# UNITED STATES PATENT AND TRADEMARK OFFICE

APPLICATION NO.	FILING DATE	FIRST NAMED INVENTOR	ATTORNEY DOCKET NO.	CONFIRMATION NO.
10/526,337	03/02/2005	Kenichi Nakamura	NAKA0102PUSA	8947
22045	7590	12/11/2007		
BROOKS KUSHMAN P.C. 1000 TOWN CENTER TWENTY-SECOND FLOOR SOUTHFIELD, MI 48075			EXAMINER HUYNH, KHOA D	
			ART UNIT	PAPER NUMBER
			3751	
			MAIL DATE	DELIVERY MODE
			12/11/2007	PAPER

## Office Action Summary

## DETAILED ACTION

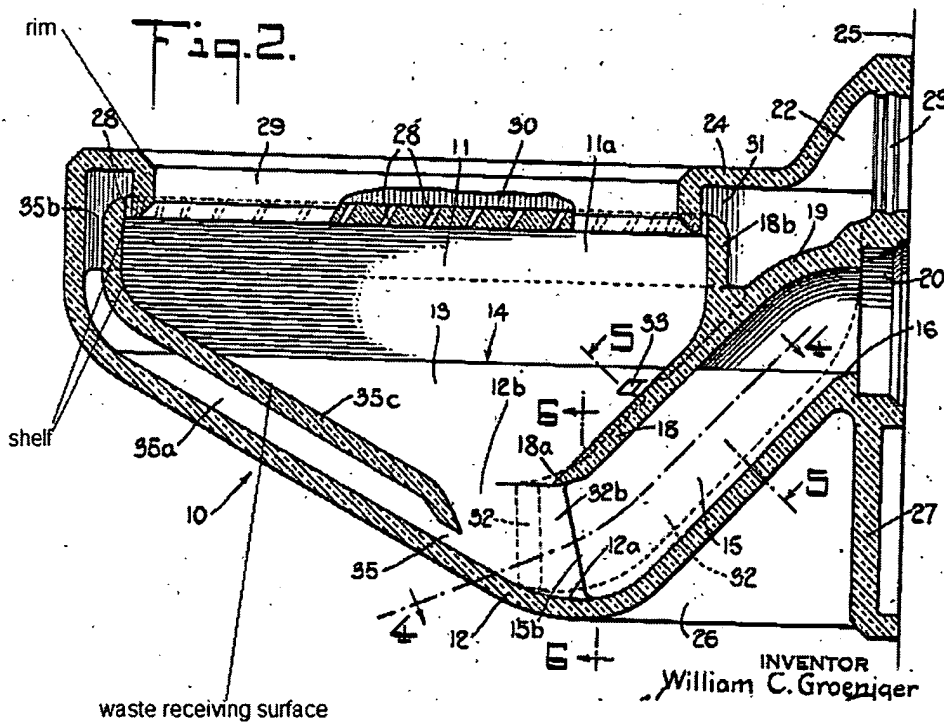
Regarding claim 1, the Groeniger reference discloses a flush toilet that uses a prescribed amount of cleansing water stored in a cleansing water tank to cleanse the toilet and discharge waste. The flush toilet includes a bowl (at 10) having a bowl-shaped waste receiving surface, a rim (*see above illustrations*) constituting an upper edge portion whose inner surface overhangs inward and a shelf (*see above illustrations*) formed between the rim and the waste receiving surface (Fig. 2), and a drainage channel (at 15) whose inlet is connected to the bottom of the bowl for discharging waste. A first water spouting section (at 32a on the left side) for spouting cleansing water onto the shelf of the bowl to form a

vortex; a second water spouting section (at 32a on the right side) for spouting cleansing water onto shelf of the bowl in the same direction as the swirling direction of the vortex; a first water channel (at 32 on the left side) for supplying cleansing water from the cleansing water tank to the first water spouting section; and a second water channel (at 32 on the right side) for supplying cleansing water from the cleansing water tank to the second water spouting section.

Applicant asserts that the Groeniger reference does not teach a shelf "which extends about the circumference of the bowl immediately below the overhanging shelf surface." See Remarks section, page 17, lines 13-16. The examiner disagrees.

Firstly, it is noted that applicant does not provide any structural limitation for the "shelf" which patentably distinguishes over the shelf of the Groeniger reference. Although the claims are interpreted in light of the specification, limitations from the specification are not read into the claims. See *In re Van Geuns*, 988 F.2d 1181, 26 USPQ2d 1057 (Fed. Cir. 1993).

Secondly, as shown in *the above illustration* and stated in the above rejection, does disclose a flush toilet including a bowl (at 10) having a bowl-shaped waste receiving surface, a rim, a shelf (*see above illustrations*) formed between the rim and the waste receiving surface (Fig. 2), a first water spouting section (at 32a on the left

side) for spouting cleansing water onto the shelf of the bowl to form a vortex; a second water spouting section (at 32a on the right side) for spouting cleansing water onto shelf of the bowl in the same direction as the swirling direction of the vortex.

Therefore, the Groeniger reference does teach applicant's invention as claimed.
